DRAINAGE INFORMATION SHEET

PROJECT TITLE: TRIPLEX APARTMENTS ZONE ATLAS/DRNG. FILE #: K-16/D27

RE: REVISED DRAINAGE PLAN FOR TRI-PLEX APARTMENTS
(K-16/D27) ENGINEER'S STAMP DATE JANUARY 27, 1987

RE: DRAINAGE PLAN FOR TRI-PLEX APARTMENTS
(K-16/D27) RECEIVED JANUARY 9, 1987

REVISIONS	SCALE: 1" = 10'	LOT 24 BLOCK 21 UNIVERSITY HEIGHTS DRAINAGE PLAN BURTON ENGINEERS, INC. ALBUQUERQUE CONSULTING CIVIL ENGINEERS Los Cruces
	DATE: 1-87	PROJECT NO. 266	
	DRAWN: RB	CHECKED: RB	
	SHEET NO. 1	of 1

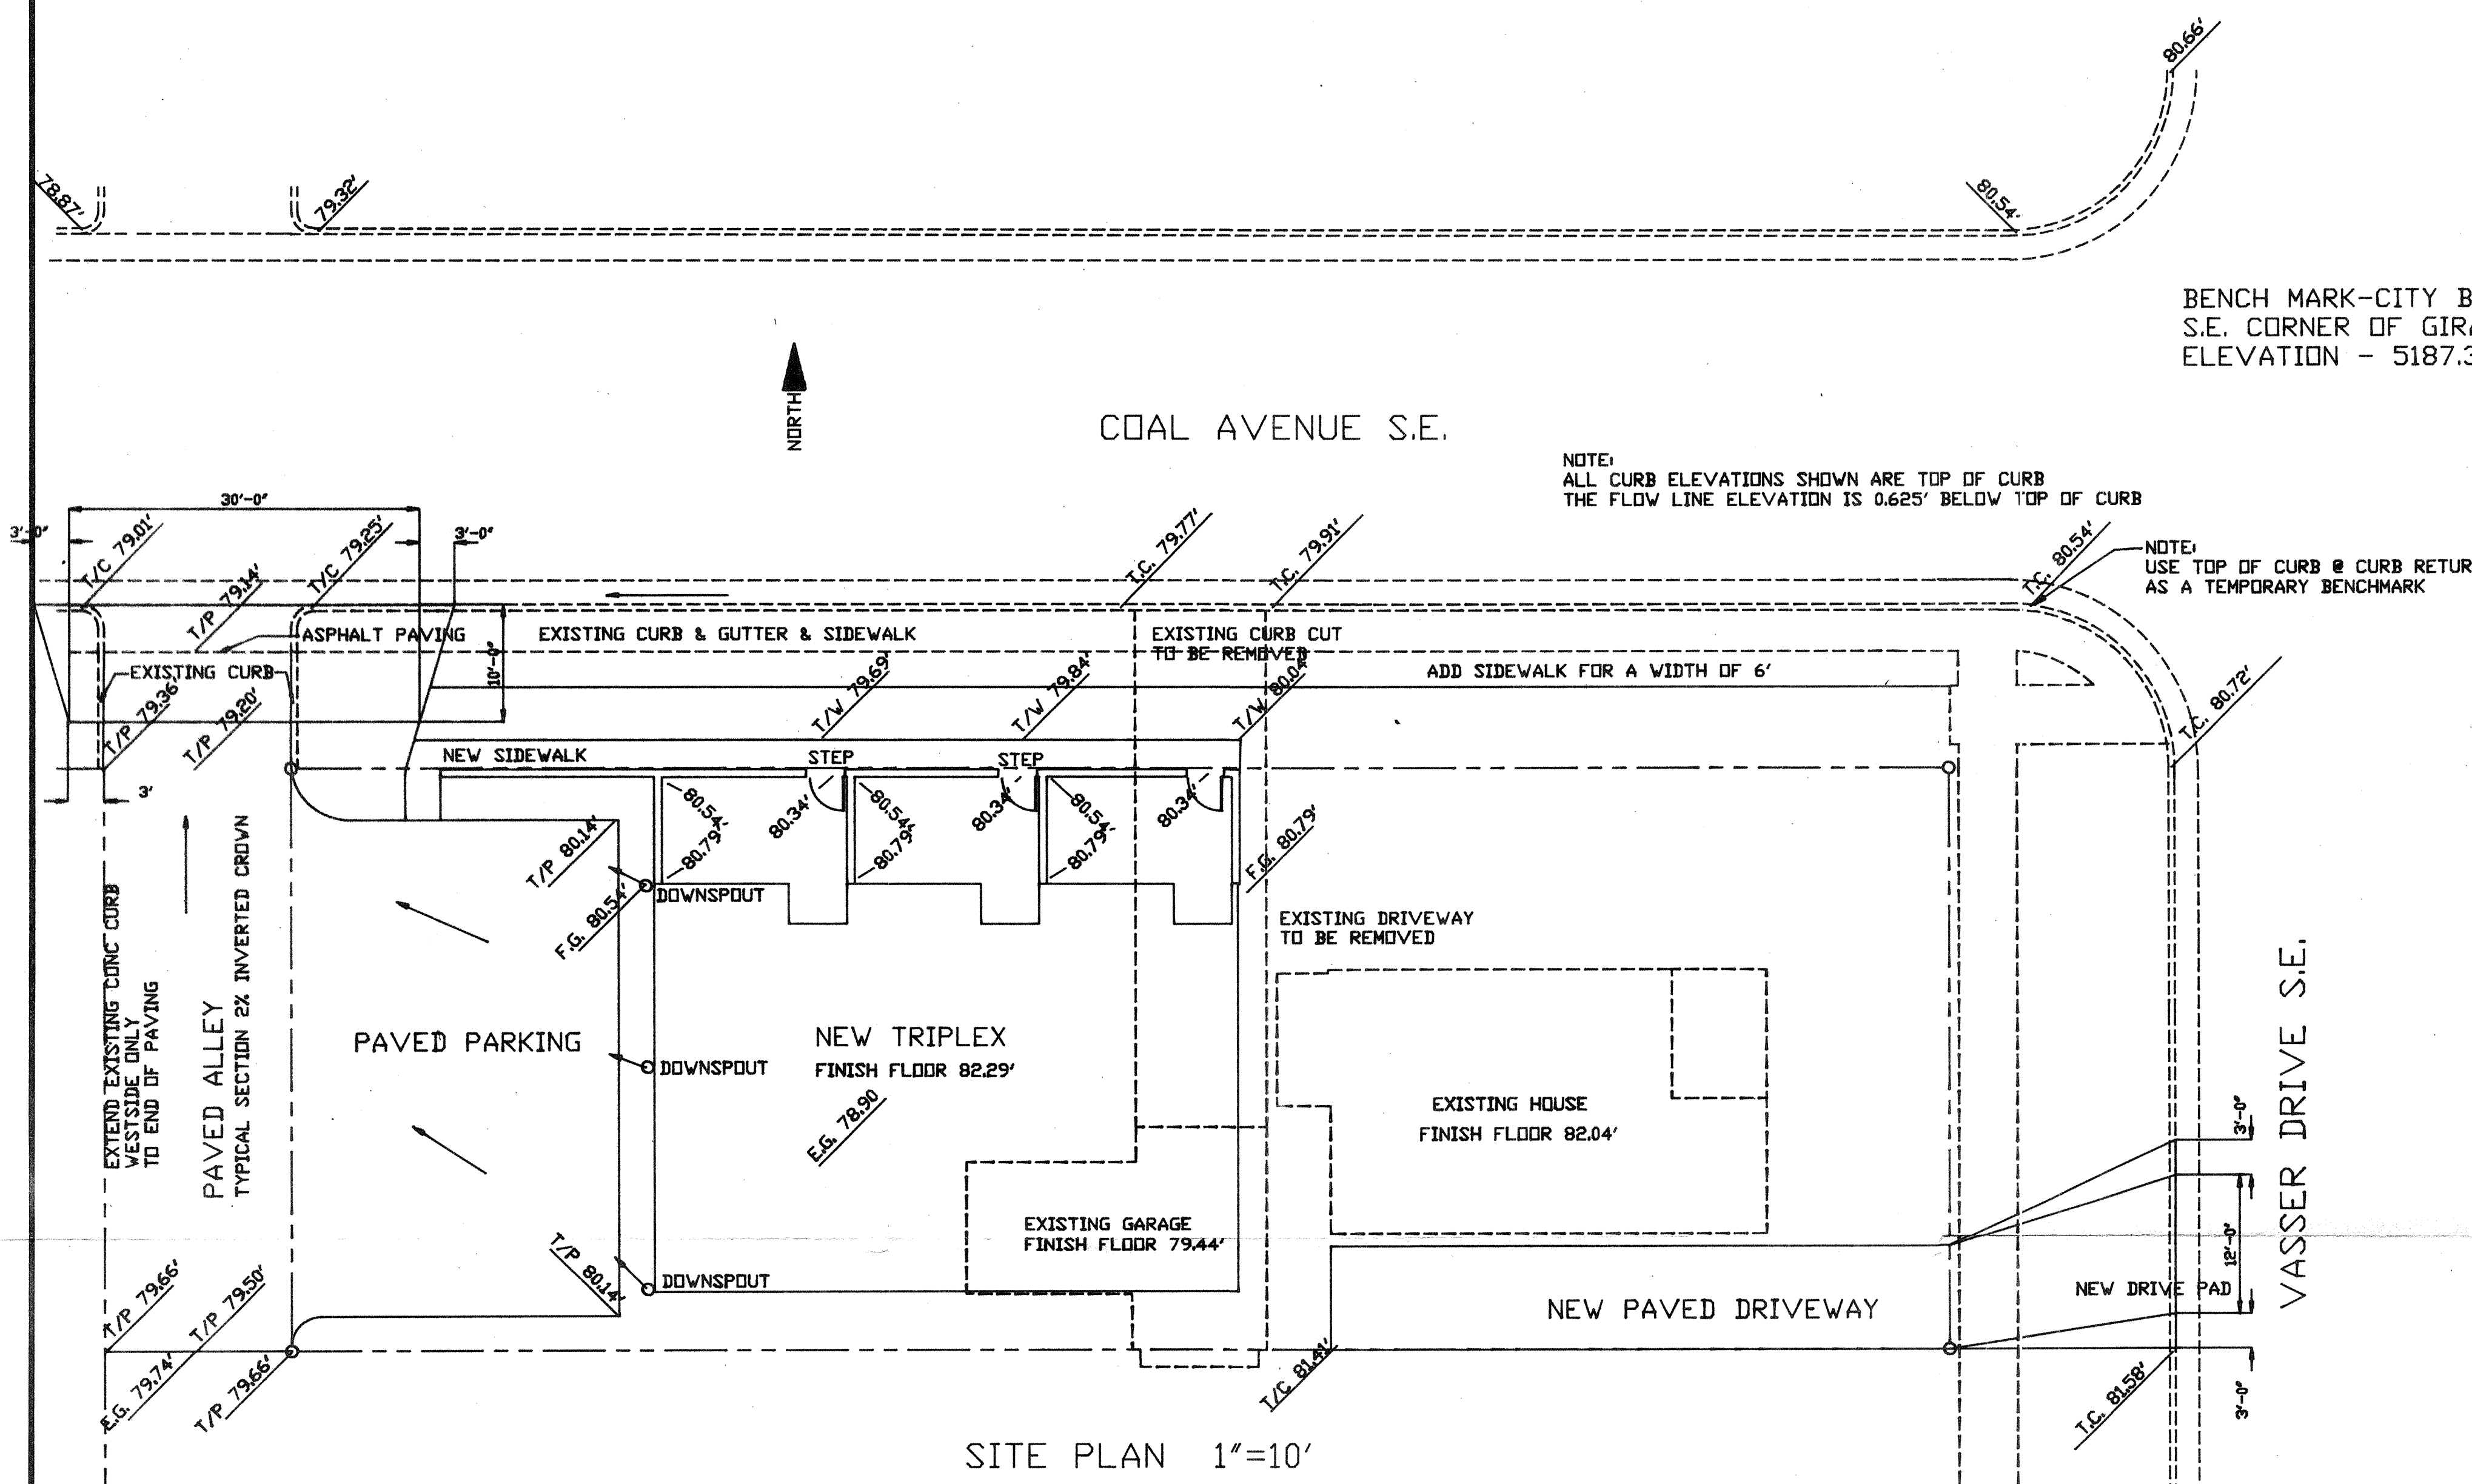
A preliminary review of your submittal for building permit approval has shown that the following information is lacking for this section to begin the review process:

INFORMATION NEEDED:

1. Use the S.C.S. curve number method for volume calculations per D.P.M.
2. Building Permit will not be issued until approved City alley grades along with a copy of the application for license agreement is submitted to our office for our records.
3. Downstream facility capacity must be analyzed before free discharge may be granted.
4. Benchmark - location, description, and elevation of the:
 - a. Albuquerque Control Survey Vertical Datum
 - b. Temporary benchmark on-site.

PLAN DRAWINGS:

1. Spot elevations adequately showing conditions on-site (to mean sea level).
2. Contours and spot elevation extending a minimum of 25' beyond property line.
3. Existing City top of curb and flow line elevations with mean-sea-level designation.
4. Finish building floor elevation with complete mean-sea-level designation.
5. Location and direction of roof drains.
6. Required spot elevations for the standard City drivepad.
7. Legend - See D.P.M. Manual Vol. 2 tables 27.3a - 27.3d for recommended standard symbols.
8. Flow pattern defined by arrows and spot elevations with mean-sea-level designation.

Attached is the revised Drainage Plan for the referenced project.
We have answered the comments in the letter as follows:

- 1) We revised our calculations to use the SCS curve number method with the following results:

Hydrologic Soil Group B - Wink-Embudo Complex
Percent Impervisions - 66%
Composite $C_n = 94$
Existing Runoff - 1.7"
Final Runoff - 2.1"
Volume -
 Existing = 0.42 cfs
 Final = 0.53 cfs
- 2) We discussed the alley grades and understand the City is to do this work.
- 3) The condition to allowing free discharge was that we perform the calculations for inlet capacity. These calculations are as follows:

We used the Albuquerque Master Drainage Plan by Bohanan and Houston Sheet K-16, Volume 1 for the contours in areas that we have not surveyed and the Albuquerque storm sewer plans for catch basin locations. The catch basins that will service the proposed project are located at the NE and SE corners of Coal and Princeton. The contour map shows that no flows west of Princeton will be tributary to these inlets.

The area that is served by these catch basins is shown on the attached map. The total is 5.55 acres with the south basin having a tributary area of 4.25 acres.

The C_n for this area is 75 based on a survey of the area. These are 2 apartment buildings and the remainder are single family residents of approximately 900 ft² on 50'x 40'+ lots.

$$Q_p = (1.7)(4.25) = 7.2 \text{ cfs}$$

The street slope on Coal Avenue is 1% to the west. Depth of flow above the gutter grade will be approximately 0.6'. The capacity of the double C inlet would be 9 cfs +. The increased flow from the project is about 0.1 cfs and is not a significant change in the inlet capacity.

- 4) We have corrected all the elevations to City of Albuquerque bench marks and set a TBM at the curb return on the SW corner of Coal.

Plan Drawings

- 1) Elevations corrected to MSL.
- ✓ 2) We have added elevations 25' from the property on all sides.
- 3) T/C and the elevations are shown to MSL. *Flowline is future street*
- 4) Elevations *not to complete*
- ✓ 5) Elevations
- 6) Elevations
- 7) We have added a legend.
- 8) We have added flow arrows.
